# City of Corpus Christi

### Planning Commission

**TECHNICAL REVIEW PLAT REQUIREMENTS  
REGULAR PLANNING COMMISSION MEETING  
July 10th, 2024**

**LONDON TOWNE SUBDIVISION UNIT 8A (FINAL OF 13.144 ACRES)**

# FINAL PLAT OF ALARCON ADDITION BLOCK 1, LOTS 1 AND 2

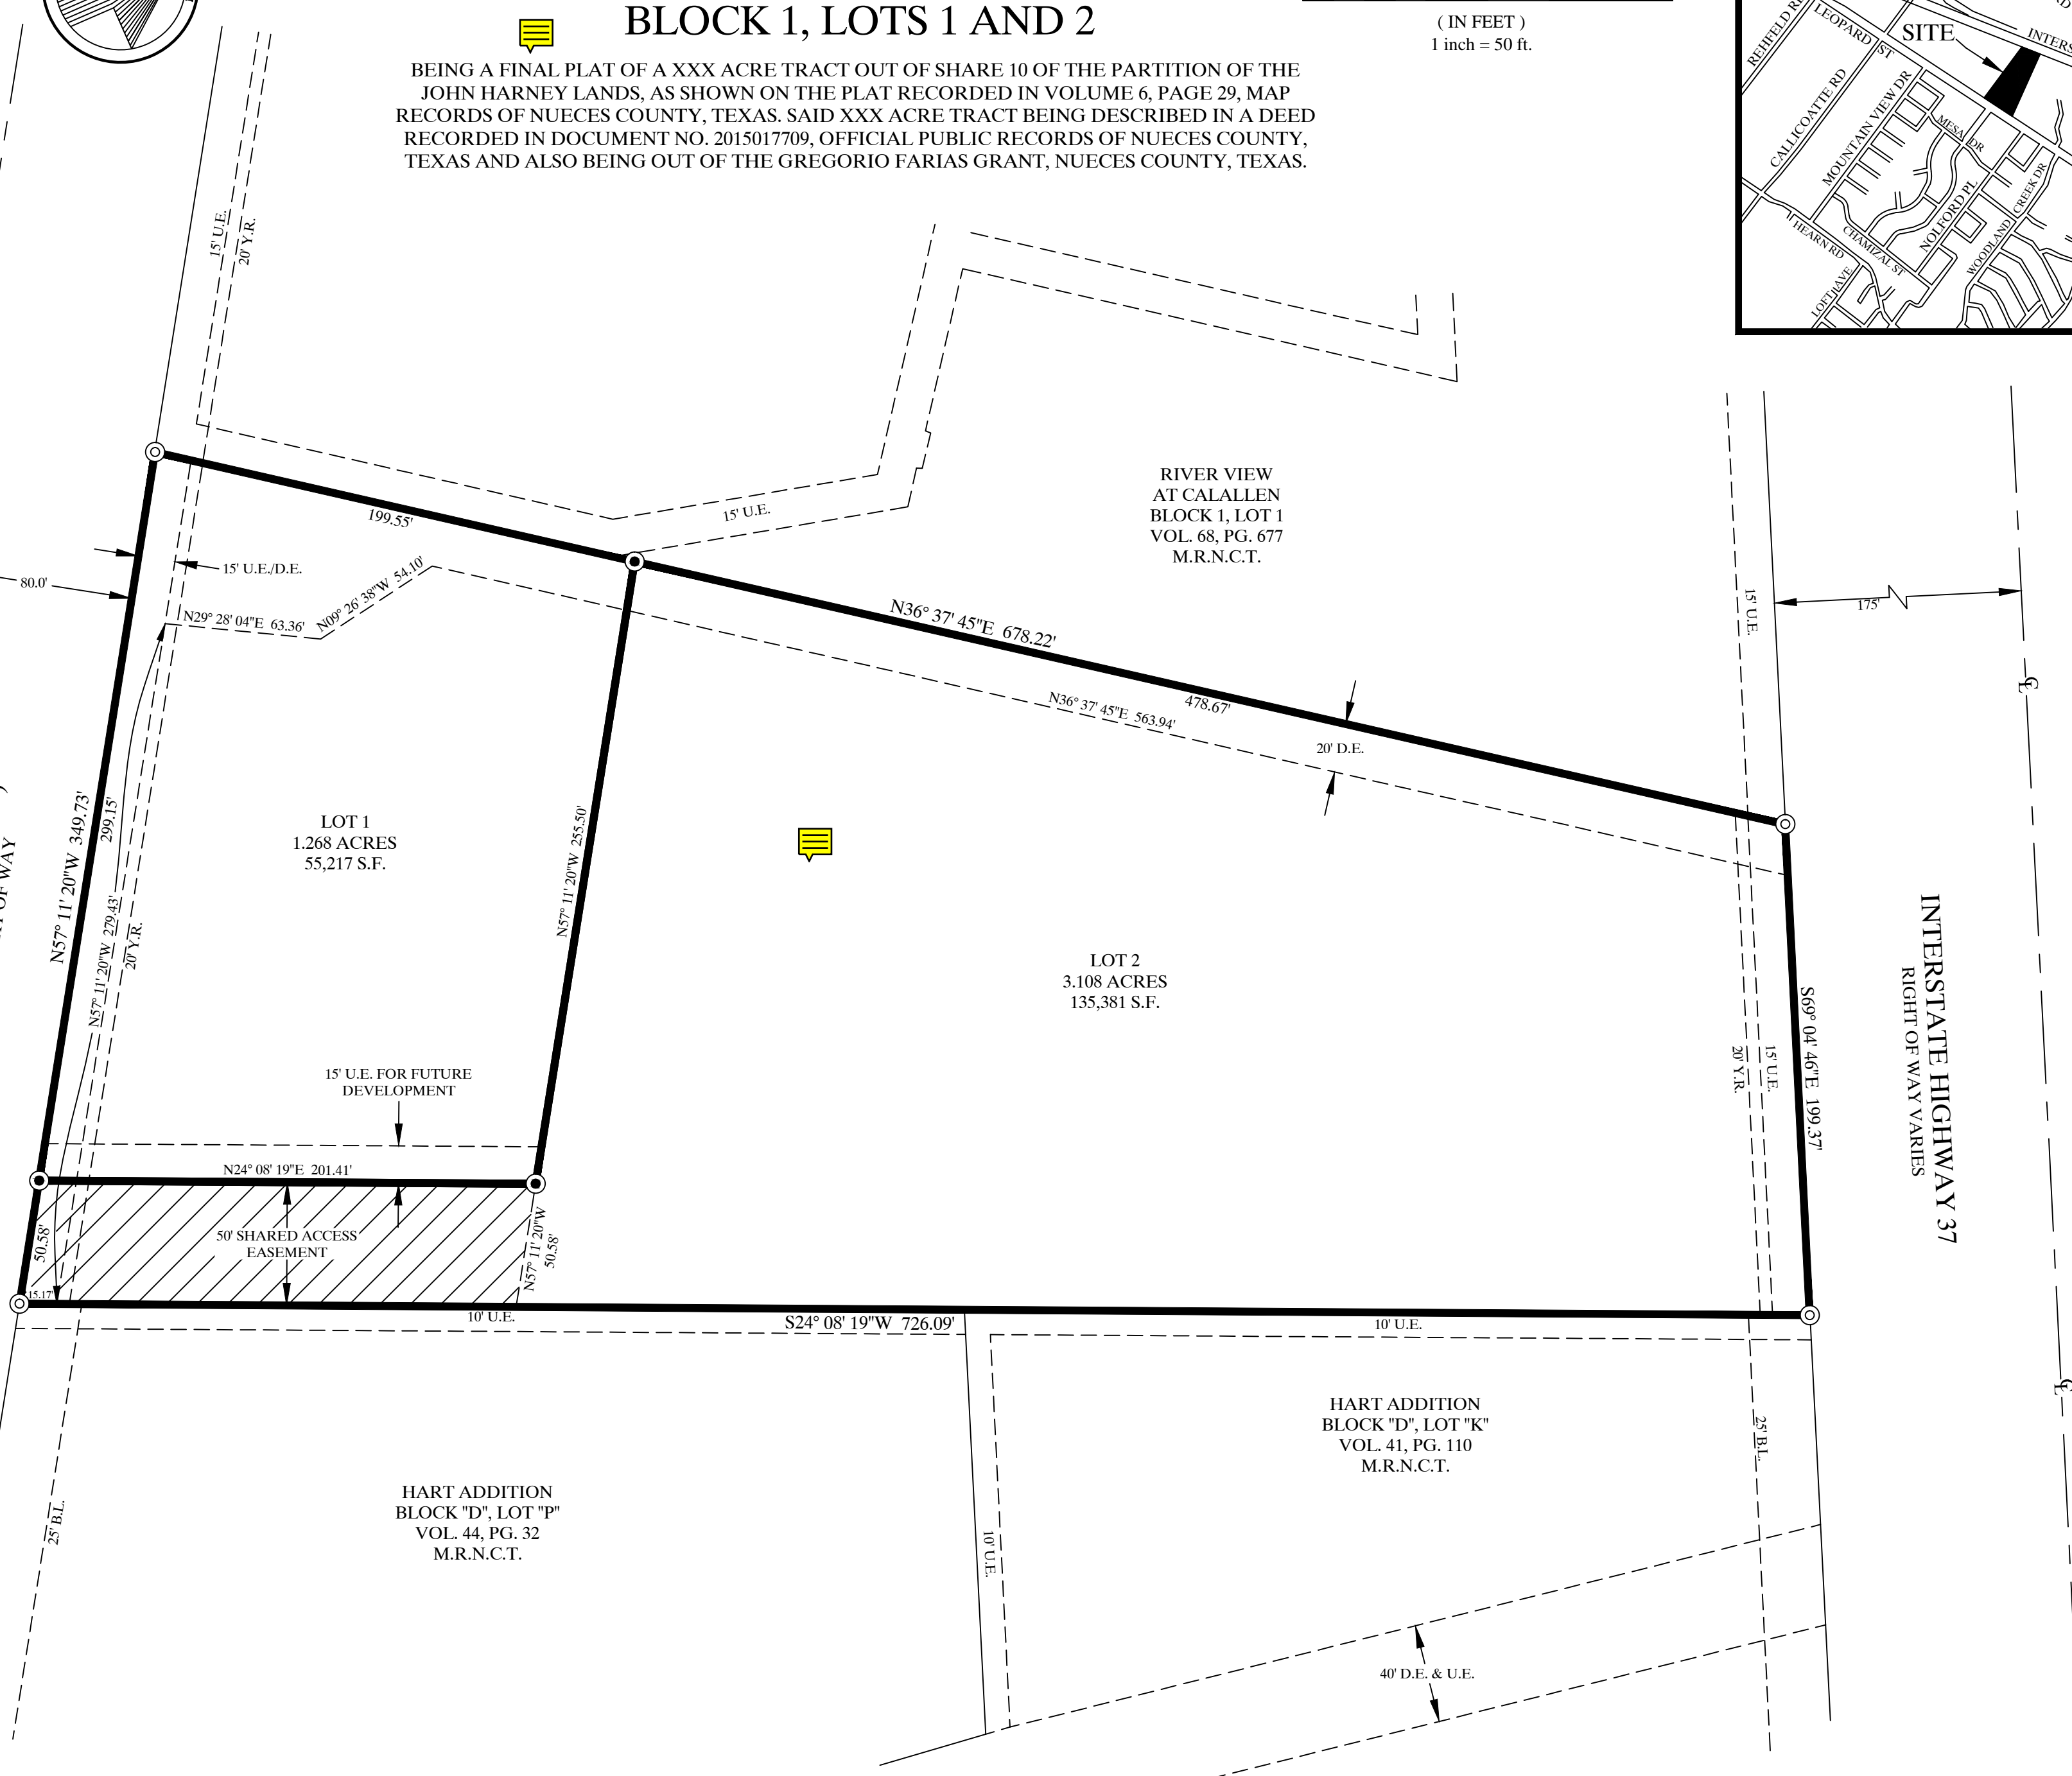
Comment ID	Page Reference	Annotation Type	Author : Department	Status	Review Comments	Applicant Response Comments
2	plat	Note	Andrea Fernandez : DS	Open	<p>TxDot Comments: Regarding access/drainage onto the state roadway system.</p> <p>□No increase in storm water discharge to State right-of-way shall be accepted by TxDOT. □TxDOT Permits will be issued in accordance with the access management standards and all applicable state and federal laws, including rules and regulations. Access connection spacing, materials, geometrics, accessibility, and other design specifications will be considered, as well as the impact on drainage and hydraulics, utility location or relocation, and the environment that will result from the requested construction of an access connection. 43 Tex. Admin. Code 11.52 (2020). □Drainage improvements shall accommodate runoff from the upstream drainage area in its anticipated maximum "build-out" or "fully developed" condition, and shall be designed to prevent overloading the capacity of the downstream drainage system □If the owner responsible for maintenance of the permanent stormwater or water quality control fails to maintain the control to TXDOT ROW, the owner shall correct the problem</p>

Comment ID	Page Reference	Annotation Type	Author : Department	Status	Review Comments	Applicant Response Comments
3	plat	Note	Andrea Fernandez : DS	Open	CCRTA Comments: This plat is located along and immediately adjacent to out bound bus stop 1385 served by the CCRTA bus Route 27 Leopard. This stop is located along the north right-of-way line of Leopard Street and is approximately 100 feet east of the Western Drive intersection with Leopard St. At this location the bus stop is in alignment with an existing mid-block Leopard St. pedestrian crosswalk. Please note that the concrete in-street stopping pad, concrete ramp and ADA compliant landing pad, Iconic bus bench, trash receptacle and sign/pole assembly are all located completely within the Leopard Street right-of-way. Should any adjustments, relocation or demolition be required for this existing bus stop, a future meeting with CCRTA staff to discuss necessary or desired alterations will be warranted.

4	plat	Note	Andrea Fernandez : DS	Open	Floodplain: No comments	
5	plat	Note	Andrea Fernandez : DS	Open	AEP Transmission: No comments	
6	plat	Note	Andrea Fernandez : DS	Open	AEP Distribution: No comments	
7	plat	Note	Andrea Fernandez : DS	Open	NASCC: No comments	
9	plat	Note	Andrea Fernandez : DS	Open	Planning comment: Confirm correct acreage as deed/NCAD acreage do not match acreage given on plat.	
10	plat	Note	Andrea Fernandez : DS	Open	Planning comment: In vicinity map "Loft Ave" should be Lott Ave (see GIS comment 2)	
13	plat	Note	Andrea Fernandez : DS	Open	Traffic Comments: 1: Plat - Existing bus stop and pedestrian crossing may require reconstruction to avoid conflicting with access easement 2: Plat - Existing drainage channel may conflict with proposed or future development 3: Plat - Recommend access easement also be extended parallel to Leopard St in front on Lot 1 4: Infor: - All new streetlight systems in residential subdivisions shall utilize concrete poles per IDM Chapter 8 section 1.2.B.a 5; Infor: - Proposed driveway access to a public City Street shall conform to access management standards outlined in Article 7 of the UDC (UDC 7.1.7)

14	plat	Note	Andrea Fernandez : DS	Open	<p>Fire comments 1-10:</p> <p>1: Infor. - Fire review will be based on use as zoned CG2. Review will not encompass the use of the property as residential apartments or townhomes. Such use will need further review.</p> <p>2: Plat - Note: All code reference is based on currently adopted International Fire Code (IFC) 2021 and Corpus Christi Water Distribution Standards.</p> <p>3: Plat -"Commercial Development shall have a fire flow of 1,500 GPM with 20 psi residual Fire hydrant every 300 feet and operational."</p> <p>4: Plat - 507.5.1 (amendment) Where Required: All premises, other than one-family detached dwellings, where buildings or portions of buildings are located more than 150 feet from a fire hydrant shall be provided with approved on-site hydrants and water mains capable of supplying the fire flow require by the fire official. The minimum arrangement being so as to have a hydrant available for distribution of hose to any portion of building on the premises at distances not exceeding 300 feet.</p> <p>5: Plat - 507.5.4 Obstruction. Unobstructed access to fire hydrants shall be maintained at all times. The fire department shall not be deterred or hindered from gaining immediate access to fire protection equipment or fire hydrants. Note: Hose lay from a hydrant will not cross an arterial street. In this instance: the hydrant across the street on</p>

15	plat	Note	Andrea Fernandez : DS	Open	<p>Fire comments 11-19:</p> <p>11: Plat - 503.2.1 Dimensions. Fire apparatus access roads shall have an unobstructed width of not less than 20 feet, exclusive of shoulders and an unobstructed vertical clearance of not less than 13 feet 6 inches.</p> <p>12: Plat - D103.1 Access road width with a hydrant. Where a fire hydrant is located on a fire apparatus access road, the minimum road width shall be 26 feet, exclusive of shoulders.</p> <p>13: Infor. - "The minimum required width of 20 feet</p>

UTILITIES SHOWN ARE AS PER THE CITY OF CORPUS CHRISTI GIS

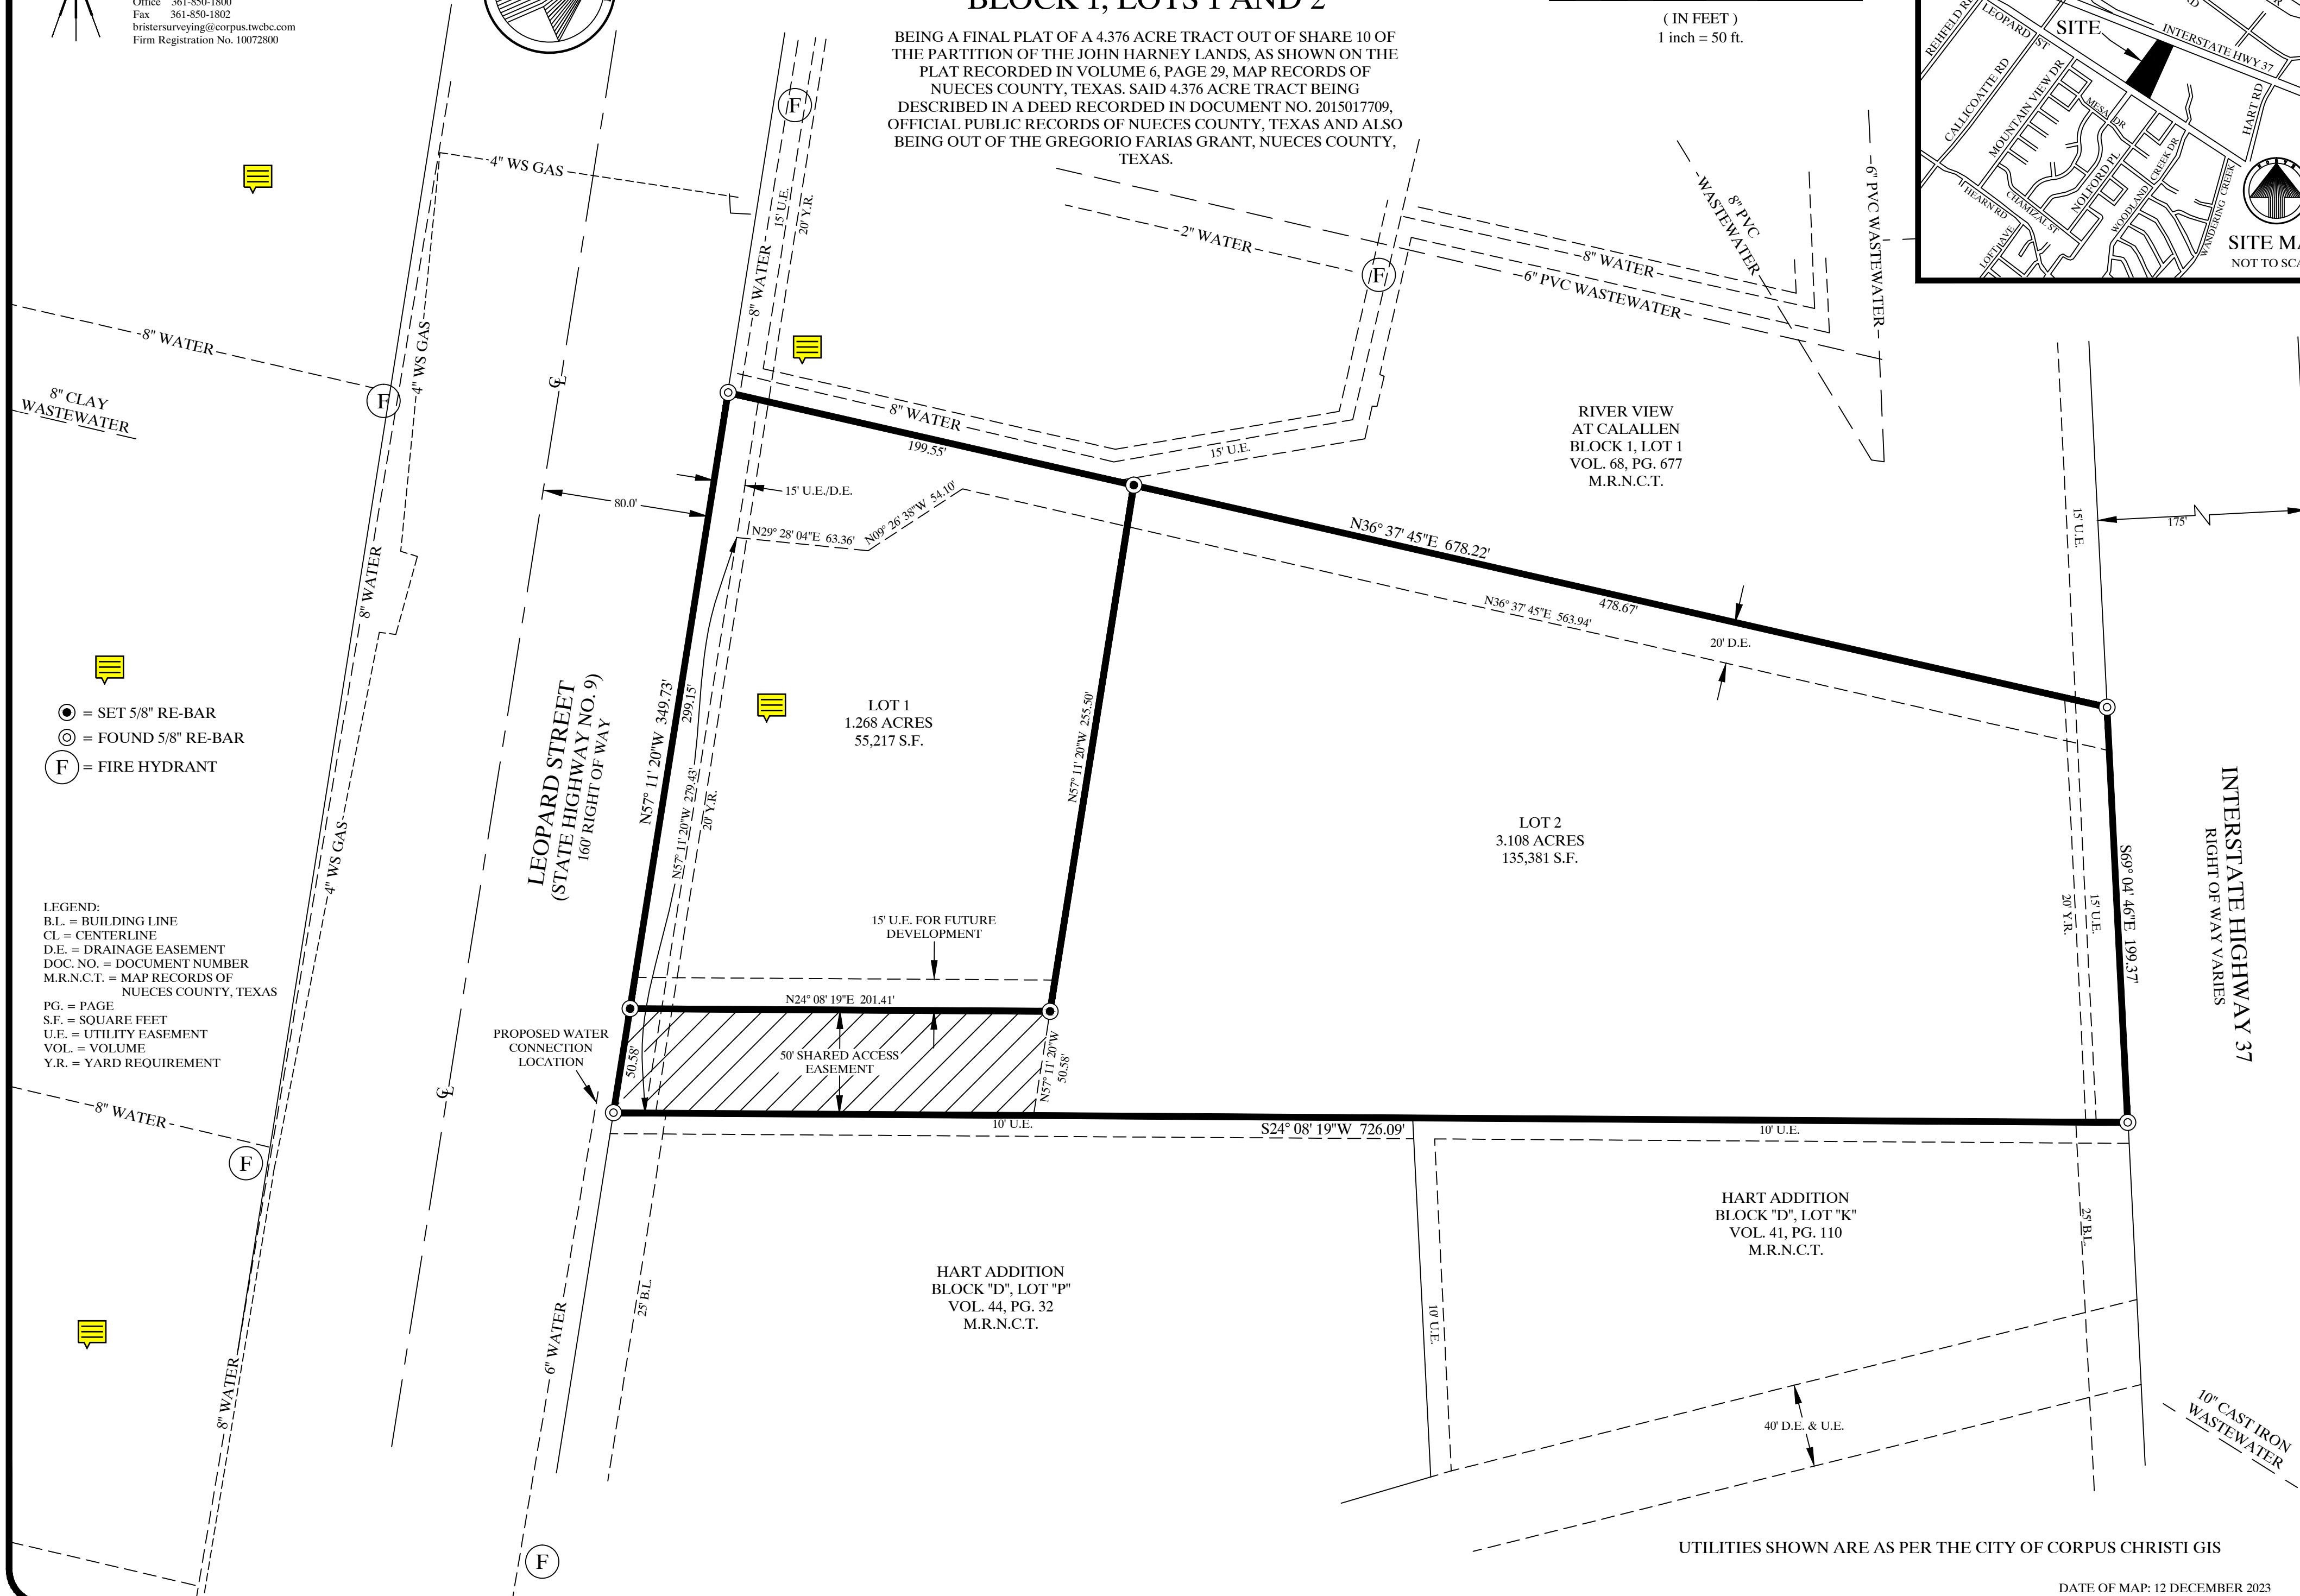
16	utility	Note	Mikail Williams : WTR	Open	Water construction is required for platting (UDC 1.2.1.D & 8.2.6; Water Distribution Standards).	
12	utility	Note	John Gonzales : WW	Open	Wastewater construction is required for platting (UDC 1.2.1.D & 8.2.7; Wastewater Collection System Standards).
